Site Accessibility Evaluation

Americans with Disabilities Act Title II (Public Services: State and Local Government)

Sahwatch Parking Garage

Accessibility Evaluation

Finding: 1

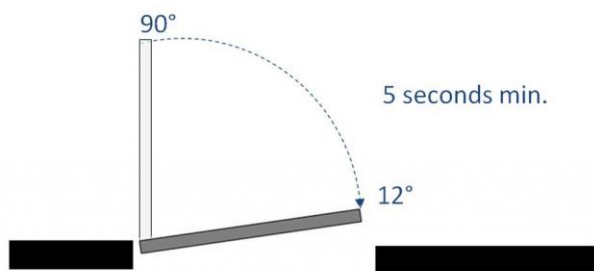
The door is equipped with a door closer and returns to a closed position too quickly.

2010 ADAS Section 404.2.8.1

2.5 seconds to closed position

Adjust door closer to allow a minimum of 5 seconds before returning to a position of 12 degrees from the latch/locking mechanism.

Finding: 4

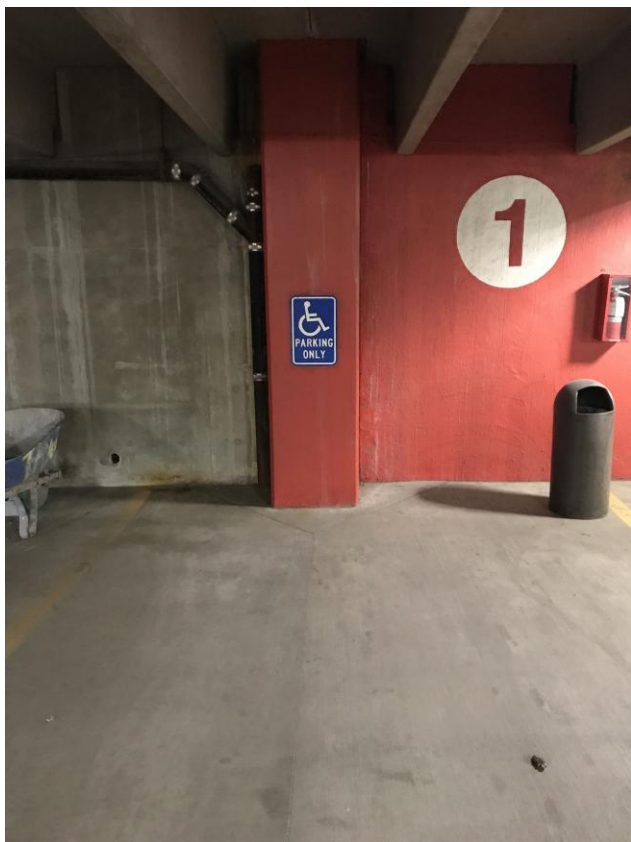
The van stall is missing a sign identifying it as a van accessible stall.

2010 ADAS Section: 502.6

Van accessible sign missing

Replace existing sign with ISA sign that also includes "Van Accessible" verbiage.

Finding: 5

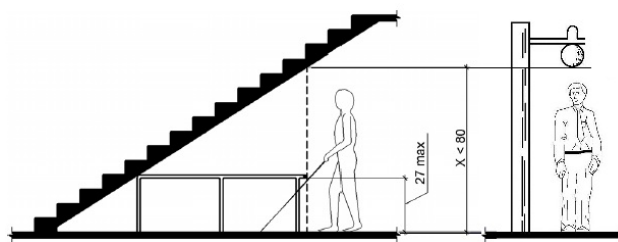
The “Stair to 1 West” overhanging sign extends down too close to the route of travel.

2010 ADAS Section: 307.4

75.5 inches above
finished floor

Adjust overhanging sign to provide a minimum of 80 inches above the walking surface measured from the bottom edge of the sign.

Finding: 6

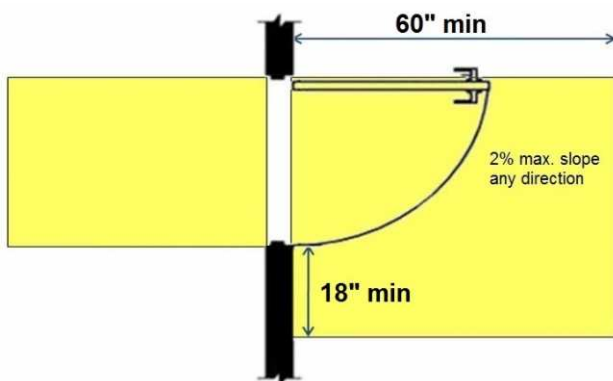
The maneuvering clearance on the pull side of the door extends less than 18 inches beyond the latch side of the door.

2010 ADAS Section: 404.2.4.1

12 inches of maneuvering space on the pull side

Finding: 9

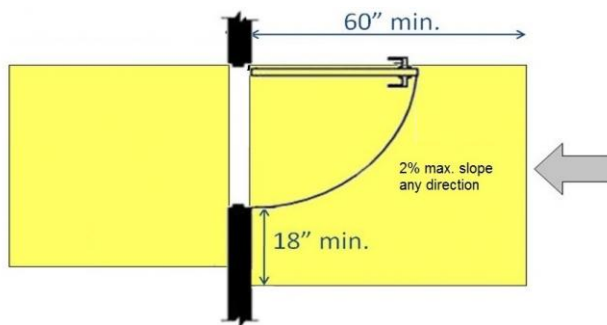
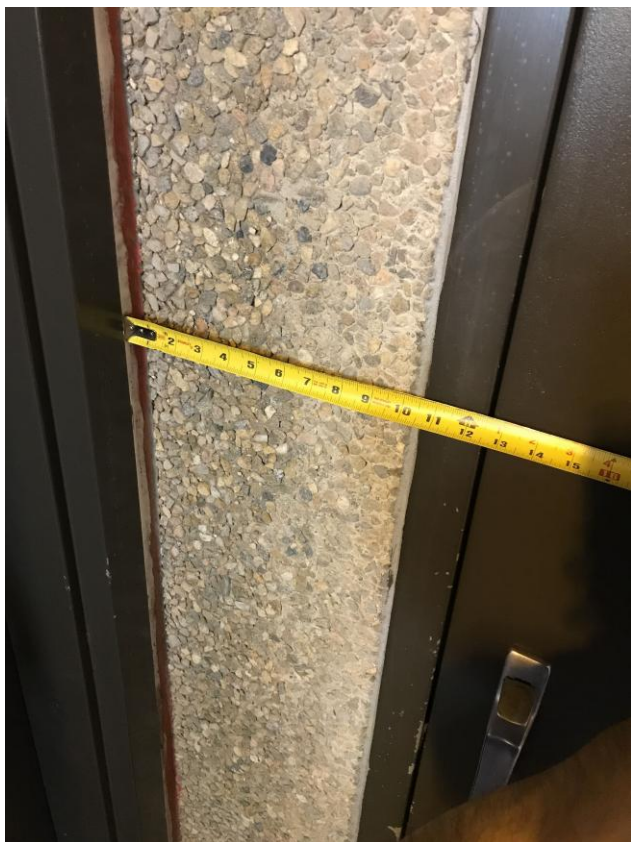
The landing on the pull side of the door extends less than 18 inches on the latch side.

2010 ADAS Section: 404.2.4.1

12 inches of
maneuvering space on
the pull side

Finding: 10

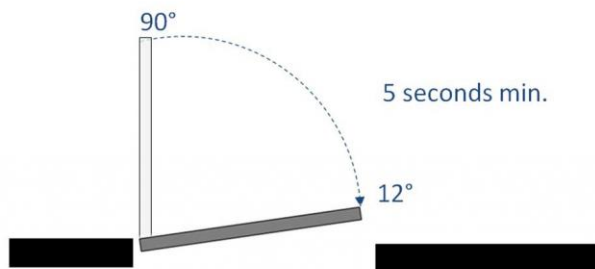
The door is equipped with a door closer and returns to a closed position too quickly.

2010 ADAS Section: 404.2.8.1

3.63 seconds to closed position

Adjust door closer to allow a minimum of 5 seconds before returning to a position of 12 degrees from the latch/locking mechanism.

Finding: 14

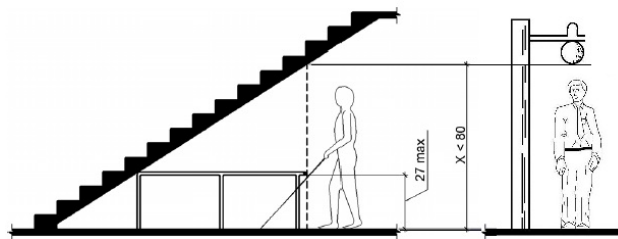
The “Stair to 2 West” overhanging sign extends down too close to the route of travel.

2010 ADAS Section: 307.4

77 inches above
finished floor

Adjust overhanging sign to provide a minimum of 80 inches above the walking surface measured from the bottom edge of the sign.

Finding: 15

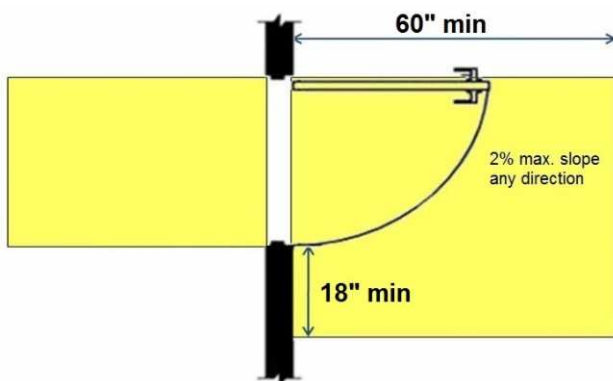
The maneuvering clearance on the pull side of the door extends less than 18 inches beyond the latch side of the door.

2010 ADAS Section 404.2.4.1

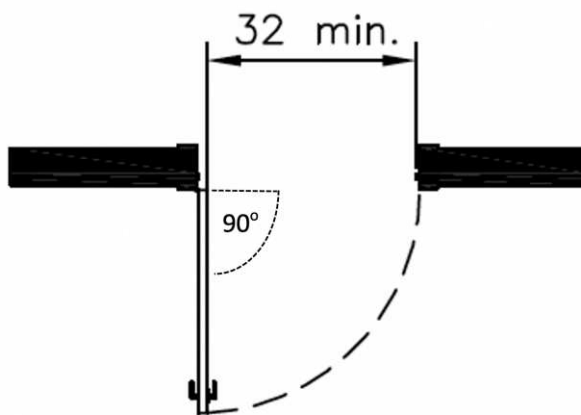
The door opening does not provide at least 32 inches between the face of the door and the opposite stop.

Door openings shall provide a clear width of 32 inches minimum. Clear openings of doorways with swinging doors shall be measured between the face of the door and the stop, with the door open 90 degrees. There shall be no projections into the required clear opening width lower than 34 inches above the finish floor or ground. Projections into the clear opening width between 34 inches and 80 inches above the finish floor or ground shall not exceed 4 inches.

5th level south door entrance very difficult to open. Adjust hinges/door closer or replace door to provide minimum width clearance of 32 inches into elevator area.
